**VILLAGE OF PENTWATER
COUNCIL
AGENDA PACKET
SEPTEMBER 22, 2025 @ 6 P.M.**

CHANGE ORDER NO.: 02

Bulletin No. 03: Chemical Sequestration

BULLETIN NO. 3

D-501

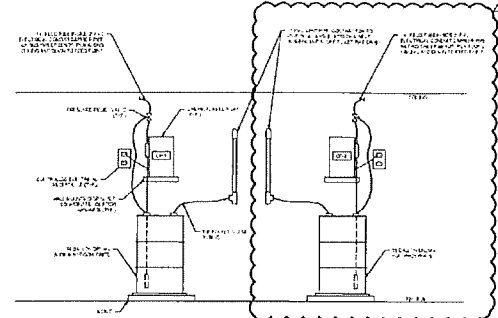
ITEM NO. 1: Phosphate Feed Addition at Well #4 for Chemical Sequestration of Iron

This item includes addition of phosphate chemical feed equipment, electrical updates and SCADA updates to allow Village of Pentwater to feed phosphate at Well #4 for iron and manganese sequestration.

- Add phosphate chemical feed equipment including one peristaltic metering pump, drum scale, chemical container, wall mount bracket, pressure relief valve, corporation stop, injection quill assembly and all appurtenances.
- Modify well discharge spool pieces to accommodate phosphate feed location.
- Include all electrical and SCADA work as shown on drawings and specifications to provide a functional phosphate chemical feed system.
- Increase sump containment depth to 8". Provide adjustable grate pedestals in lieu of beam.

D-101, D-501, E-102, E-601
